Access Compliance Report

Public Rights-of-Way

(Curb Ramps)

Intersection ID: 49125	Main Street: LEGOLAS_LN	Cross Street: LAVETA_RD	Location: SW
ADA ID: 59194112E060	Ramp Type: Combination2	Initial Pass/Fail: Fail	Overall Compliance: No
		Severity Score: 12.5

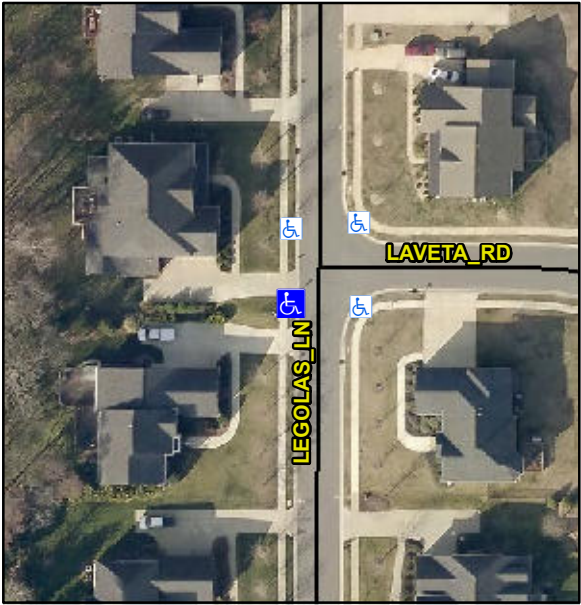
Codes/Mitigation Info/Possible Solution			Field Measurements/Component Compliance		
	Possible Solutions:		Compliance	Description	Data
	Remove & Replace Entire Ramp.		N/A	Ramp Length LT (in)	N/A
			N/A	Ramp Width LT (in)	N/A
			N/A	Ramp Slope LT (%)	N/A
			N/A	Ramp XSlope LT (%)	N/A
			N/A	Ramp Length (in)	47.0
			No	Ramp Width (in)	47.0
			N/A	Flare Type LT	N/A
			N/A	Flare Slope LT (%)	N/A
			N/A	Flare Traversable LT?	N/A
			N/A	Landing Length (in)	N/A
			N/A	Landing Width (in)	N/A
			N/A	Landing Slope (%)	N/A
			N/A	Landing X Slope (%)	N/A
			N/A	Landing Curb? (Y/N)	N/A
			N/A	Shared Landing?	N/A
			N/A	Gutter Ponding?	N/A
			N/A	Gutter Lip Ht (in)	N/A
			N/A	Painted X Walk1?	No
				X Walk 1 Direction	To E
				X Walk 1 Width (in)	N/A
				X Walk 1 Slope (%)	3.7
				X Walk 1 X Slope (%)	1.7
			N/A	Ramp inside XWalk1?	N/A
				Road Slope (%)	N/A
				Road X Slope (%)	N/A
			N/A	Ramp Length RT (in)	25.5
			Yes	Ramp Width RT (in)	48.0

Yes	Ramp Slope RT (%)	8.3
			Yes	Ramp XSlope RT (%)	0.1
			No	Ramp Slope (%)	8.4
			Yes	Ramp XSlope (%)	1.8
			N/A	Flare Type RT	N/A
			N/A	Flare Slope RT (%)	N/A
			N/A	Flare Traversable RT?	N/A
			N/A	DWS Provided?	N/A
			N/A	DWS Contrast?	N/A
			N/A	DWS Length (in)	N/A
			N/A	DWS Full Width?	N/A
			N/A	DWS Offset (in)	N/A
			N/A	Gutter Slope (%)	N/A
			N/A	Gutter X Slope (%)	N/A
			N/A	Painted X Walk2?	N/A
				X Walk 2 Direction	N/A
				X Walk 2 Width (in)	N/A
				X Walk 2 Slope (%)	N/A
				X Walk 2 X Slope (%)	N/A
			N/A	Ramp inside XWalk2?	N/A
				Clear Space?	N/A
			N/A	Clear Space to XWalk (in)	N/A
			N/A	Any Obstruction?	N/A
				Obstruction Type	N/A
					N/A
			N/A	Storm Grate/Utility Hazard?	N/A
				Storm Grate/Utility Type	N/A
					N/A
			Yes	Surface Condition? (G/P)	Good
				Curb Slope (%)	14.0

Not Found, R304.5.1, R304.2.2

Remove & Replace Entire Ramp.
